APPLICATION NO.	FILING DATE	FIRST NAMED INVENTOR	ATTORNEY DOCKET NO.	CONFIRMATION NO.
09/901,000	07/09/2001	Teruo Kamada	SHM/12585	6853

Office Action Summary

Application No.
09/901,000

Applicant(s)
KAMADA, ET AL

FIG. 19A
(PRIOR ART)

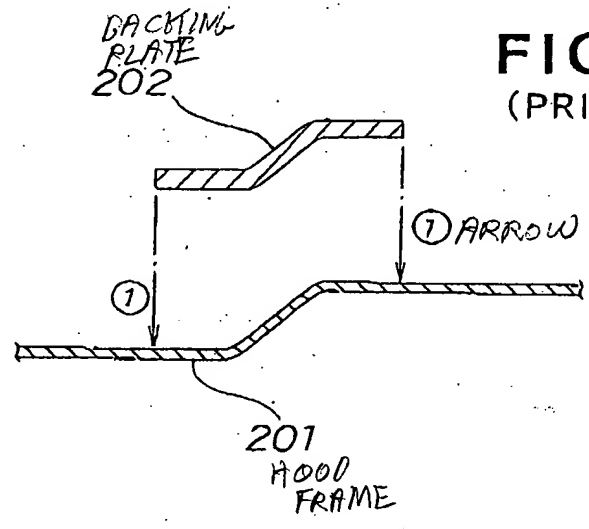
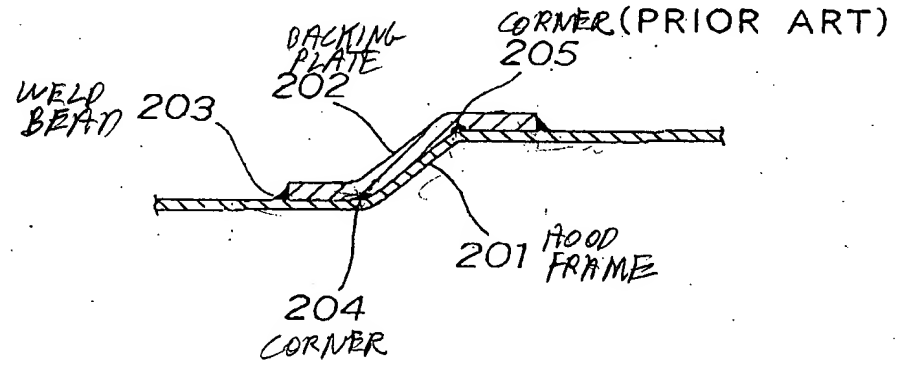
7. Claims 1-3, 9, 10 and 12-15 are rejected under 35 U.S.C. 103(a) as being unpatentable over Prior Art Figures 19A and 19B and associated Background portion of the Instant Application related to these Figures, in view of British Patent 2197810.

Prior art Figures 19A and 19B and associated Background portion of the Instant Application related to these Figures teaches a vehicular part comprising a blank material (201) formed from a sheet metal (line 13 of page 2 of the Instant Application) and having a bent portion (204 and 205); and

a backing plate (202) joined with the blank material (Figures 19A and 19B) and having a bent portion (204 and 205) corresponding in position to, and bent along a same bending line as, the bent portion of the blank material.

Prior art Figures 19A and 19B and associated Background portion of the Instant Application related to these Figures fails to teach the backing plate has at least one aperture formed at the bent portion and located on the bending line.

Therefore, it would have been obvious to one of ordinary skill in the art at the time the invention was made to utilize a row of holes along the bending line of the bent portion of the backing plate of Prior Art Figures 19A and 19B, as taught by British Patent 2197810.

Regarding claim 9, note that Prior Art Figures 19A and 19B show a backing plate and blank material which are configured similarly to Applicant's Figures 1-3.

8. Claims 1-3, 9, 10 and 12-15 are alternatively rejected under 35 U.S.C. 103(a) as being unpatentable over Prior Art Figures 19A and 19B and associated Background portion of the Instant Application related to these Figures, in view of Japanese Patent 59-202119.

Prior art Figures 19A and 19B and associated Background portion of the Instant Application related to these Figures teaches a vehicular part comprising a blank material (201) formed from a sheet metal (line 13 of page 2 of the Instant Application) and having a bent portion (204 and 205); and

a backing plate (202) joined with the blank material (Figures 19A and 19B) and having a bent portion (204 and 205) corresponding in position to, and bent along a same bending line as, the bent portion of the blank material.

Prior art Figures 19A and 19B and associated Background portion of the Instant Application related to these Figures fails to teach the backing plate has at least one aperture formed at the bent portion and located on the bending line.

Therefore, it would have been obvious to one of ordinary skill in the art at the time the invention was made to utilize a row of holes along the bending line of the bent portion of the backing plate of Prior Art Figures 19A and 19B, as taught by Japanese Patent 59-202119.

Regarding claim 9, note that Prior Art Figures 19A and 19B show a backing plate and blank material which are configured similarly to Applicant's Figures 1-3.
